SAFETY RECALL

Mack Trucks Inc.
Greensboro, NC USA

Date	Number	Release	Page
03.2024	SC0458	02	1(7)

Mack Air Tank Volume GR

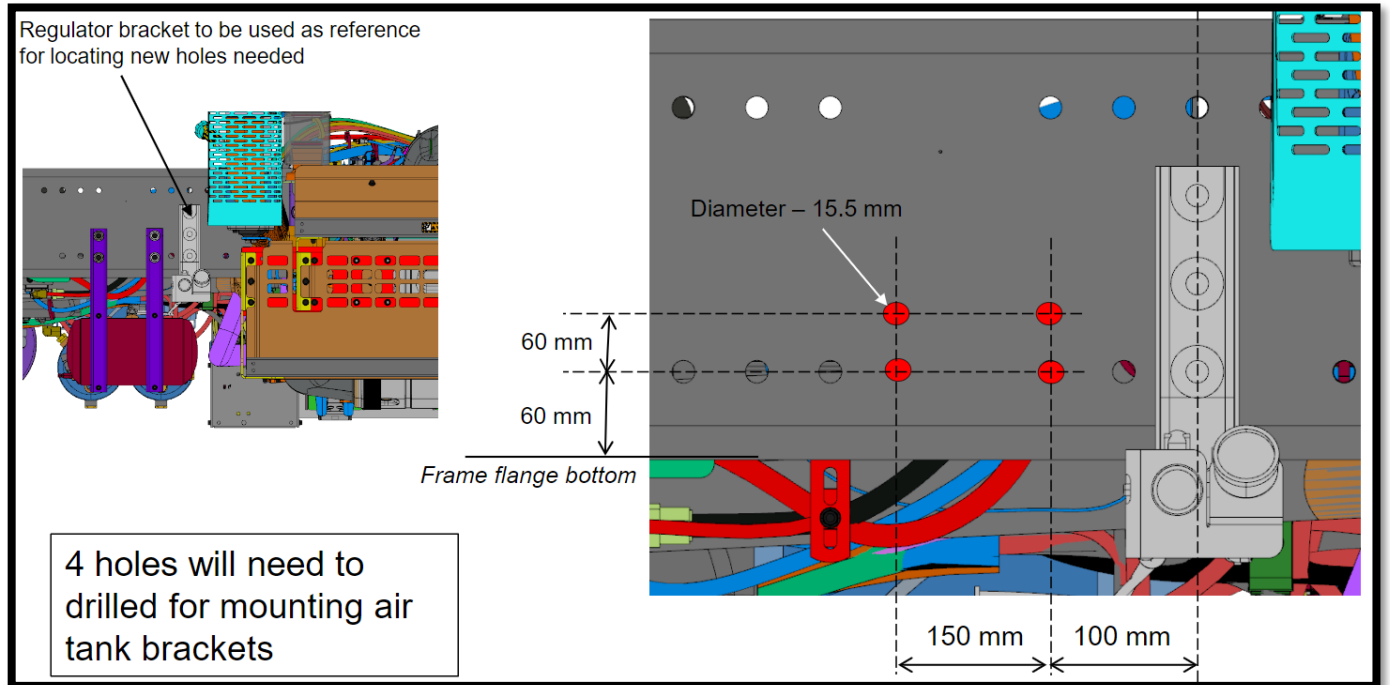
6. The retrofit air tank will be installed on the right-hand side of the truck on the frame.

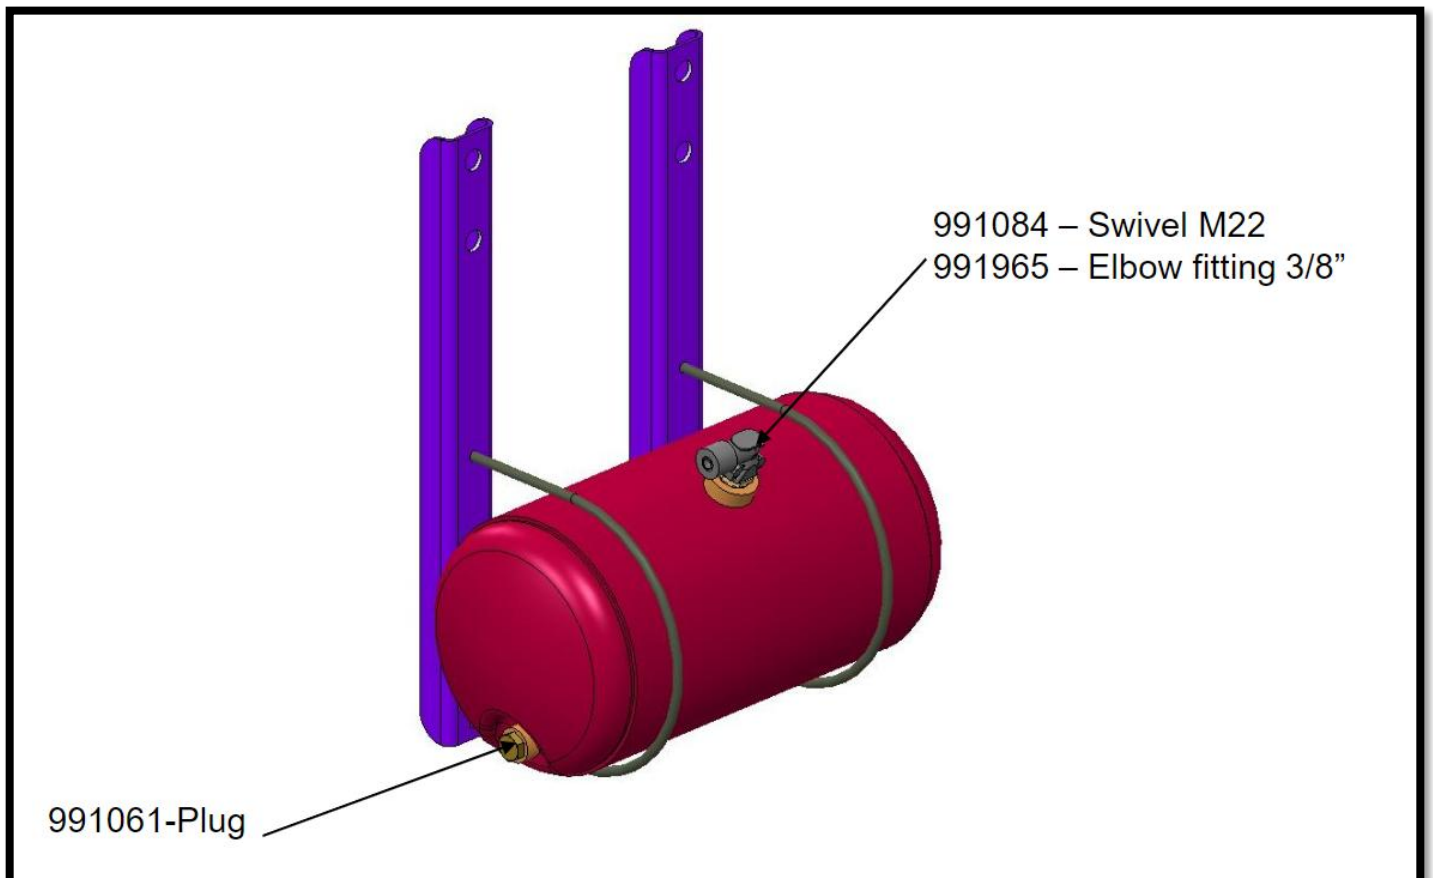
7. Begin by drilling four 15.5mm holes in the frame to mount the air tank brackets. Use the measurements below.

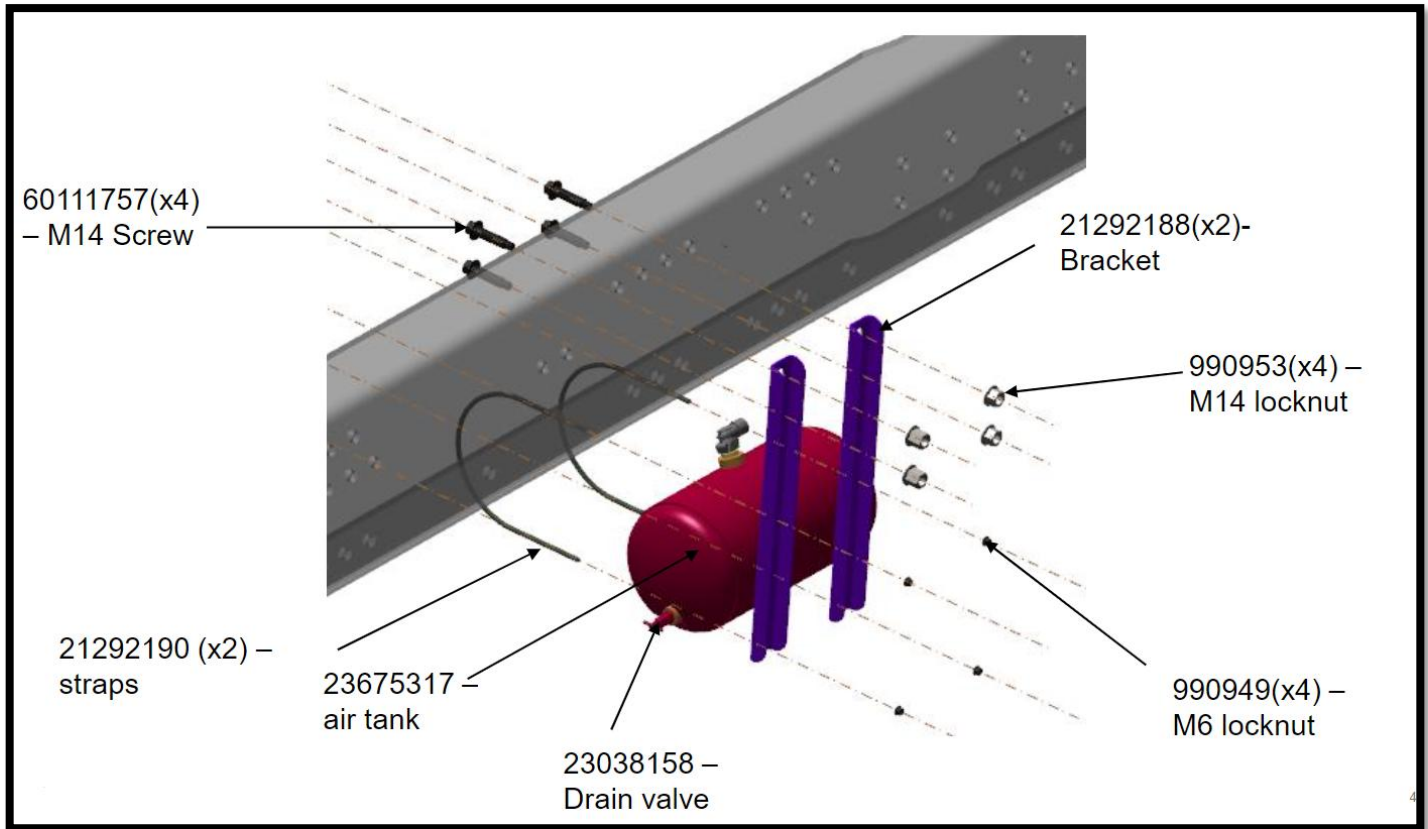
8. Ensure the plug, swivel, and elbow fitting have been installed on the tank prior to mounting it to the frame.

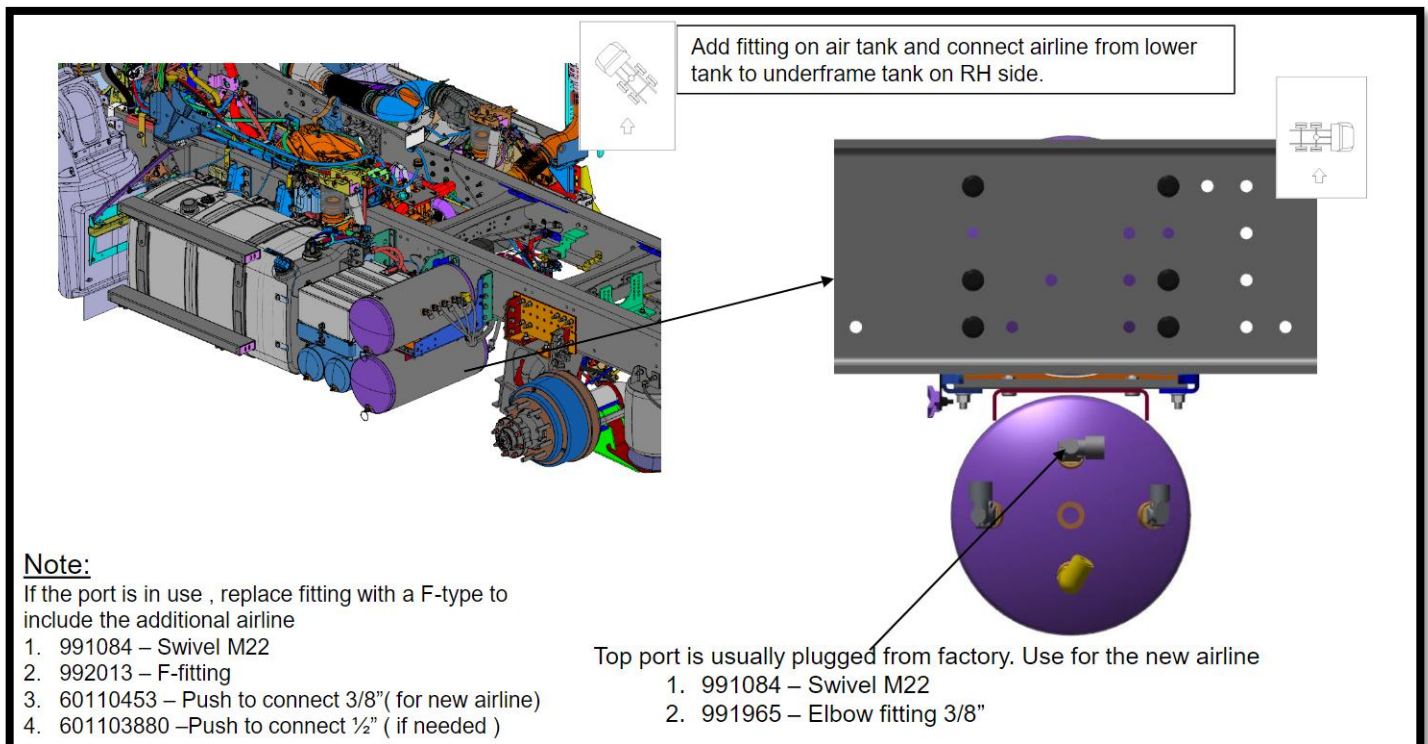
9. Once drilled, install the brackets, air tank, and straps to the frame using appropriate hardware.

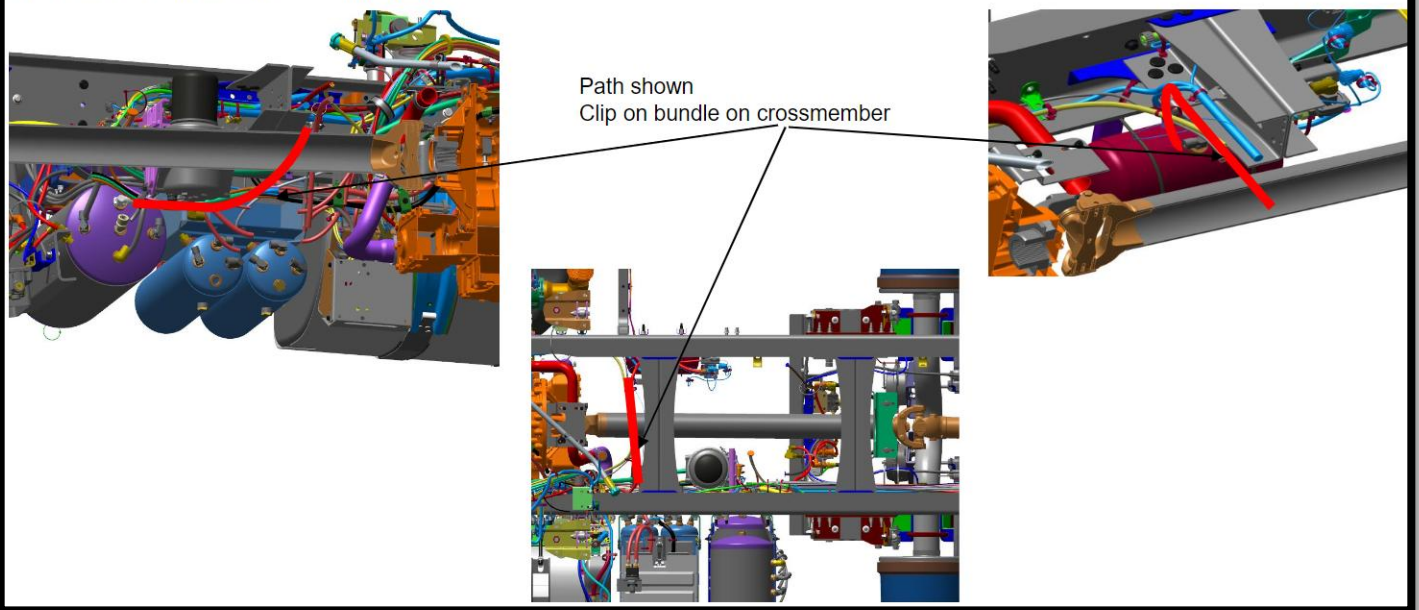
11. Route the 3/8" airline from rack lower air tank to under frame tank. Airline can be clipped on airline bundle on the transmission crossmember.

A 3/8" airline will need to be routed from rack lower airtank to under frame tank.
Airline can be clipped on airline bundle on the transmission crossmember.
Views shown are reference for routing path.
